Access Compliance Report

Public Rights-of-Way

(Curb Ramps)

Intersection ID: 53890	Main Street: PUTNAM_PL	Cross Street: PAW_VALLEY_LN	Location: NW
ADA ID: EAD87221FF42	Ramp Type: PerpDiag	Initial Pass/Fail: Fail	Overall Compliance: No
		Severity Score: 25

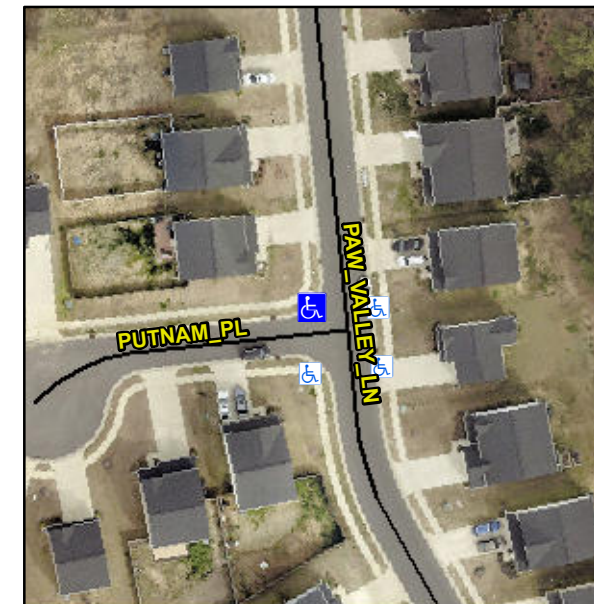
Not Found, R304.2.2, R304.5.3

Compliance	Description	Data	Compliance	Description	Data
N/A	Ramp Length (in)	48.5	No	Ramp Slope (%)	11.2
Yes	Ramp Width (in)	48.0	No	Ramp XSlope (%)	5.1
N/A	Flare Type LT	N/A	N/A	Flare Type RT	N/A
N/A	Flare Slope LT (%)	N/A	N/A	Flare Slope RT (%)	N/A
N/A	Flare Traversable LT?	N/A	N/A	Flare Traversable RT?	N/A
N/A	Landing Length (in)	N/A	N/A	DWS Provided?	N/A
N/A	Landing Width (in)	N/A	N/A	DWS Contrast?	N/A
N/A	Landing Slope (%)	N/A	N/A	DWS Length (in)	N/A
N/A	Landing X Slope (%)	N/A	N/A	DWS Full Width?	N/A
N/A	Landing Curb? (Y/N)	N/A	N/A	DWS Offset (in)	N/A
N/A	Shared Landing?	N/A			
N/A	Gutter Ponding?	N/A	N/A	Gutter Slope (%)	N/A
N/A	Gutter Lip Ht (in)	N/A	N/A	Gutter X Slope (%)	N/A
N/A	Painted X Walk1?	No	N/A	Painted X Walk2?	No
	X Walk 1 Direction	To S		X Walk 2 Direction	To E
N/A	X Walk 1 Width (in)	N/A	N/A	X Walk 2 Width (in)	N/A
	X Walk 1 Slope (%)	2.7		X Walk 2 Slope (%)	7.5
	X Walk 1 X Slope (%)	5.9		X Walk 2 X Slope (%)	2.2

Remove & Replace Curb Ramp With Two New Directional Ramps or Equivalent.
